**Technical Drainage Study
For
Addendum-1 to Update #1
Deer Springs Master Drainage Plan
March 3, 2005**

Re: Addendum-1 to Update #1 to the Deer Springs Master Drainage Plan (CLV # DS3651)

CITY OF LAS VEGAS		DATE:
INTER-OFFICE MEMORANDUM		March 25, 2005
TO: Land Development Services Department of Public Works		FROM: Albert Sung, P.E.  Flood Control Project Engineer Department of Public Works
SUBJECT: Drainage Study for: Centennial Hills Leisure Center Deer Springs Way Improvements		COPIES TO: Stantec
Cross Streets:	Deer Springs and Buffalo	Michael Vlaovich, AIA, CLV
File Number:	F:\Depot\DSMemos\DS3651C.doc	Bart Anderson, P.E., DevCo
Parcel Number:	A portion of 12521701011	Lochsa
Zoning Action:	SDR-4749	
FEMA Flood Zone	YES NO X	
Proposed Storm Drain	YES X NO

NOMOGRAPH - INLET CONTROL RCP

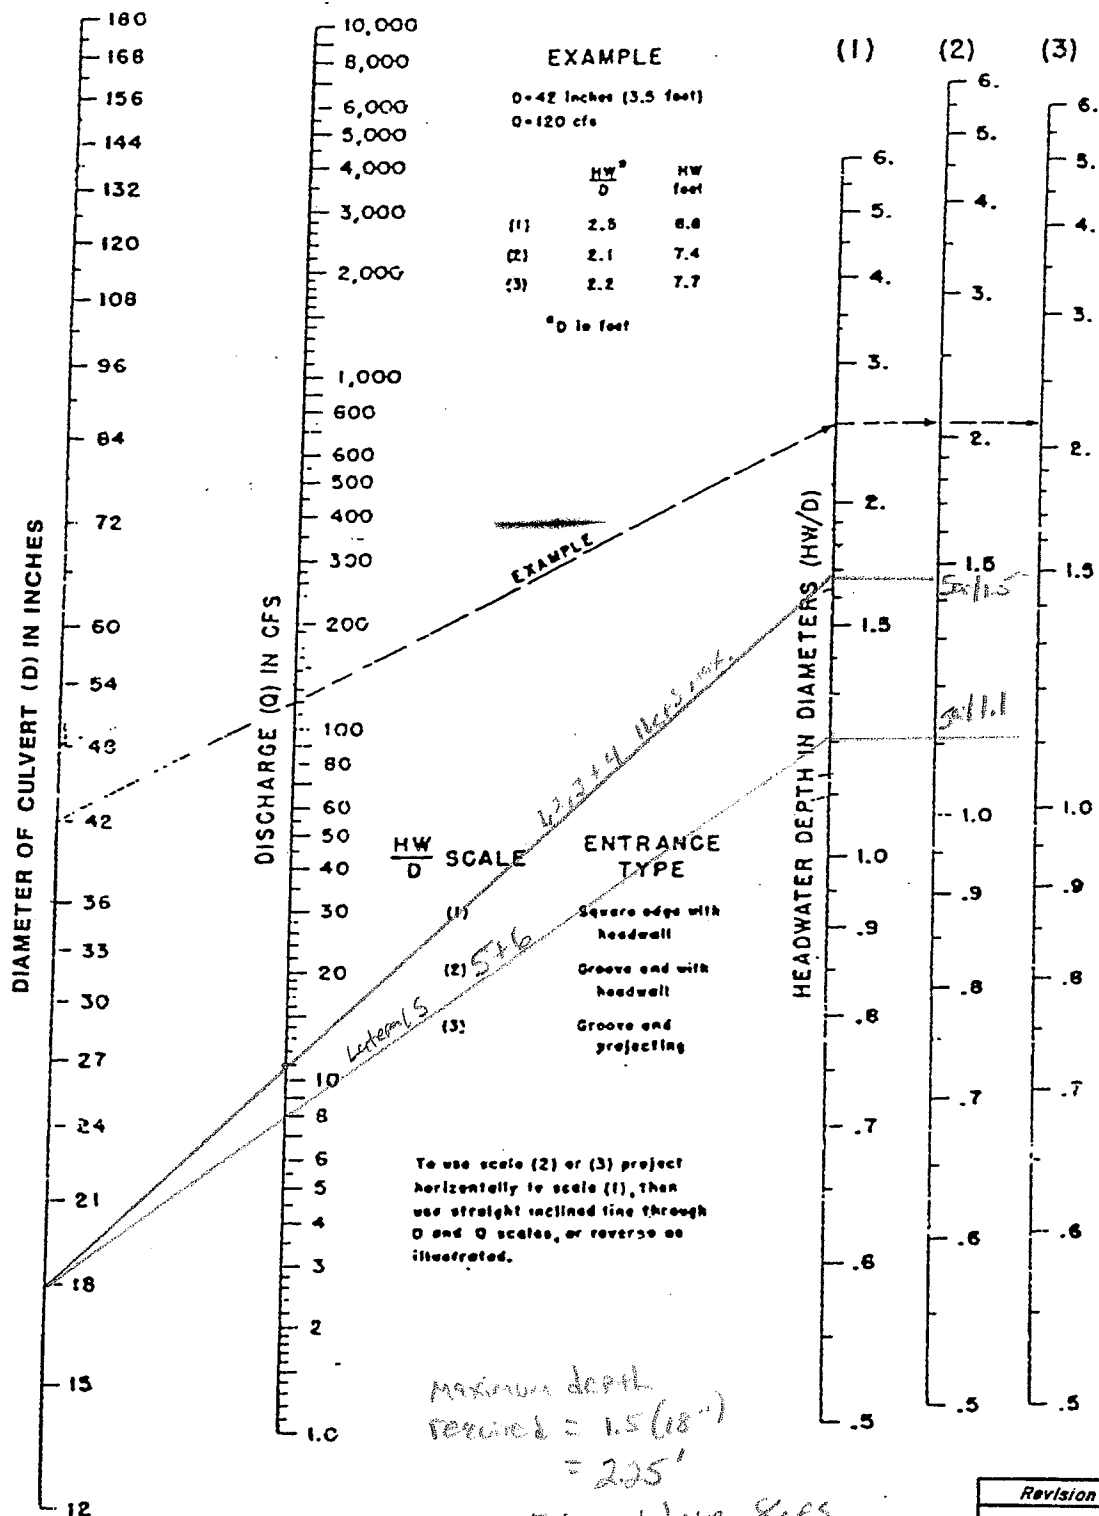
We have APX 4 ft
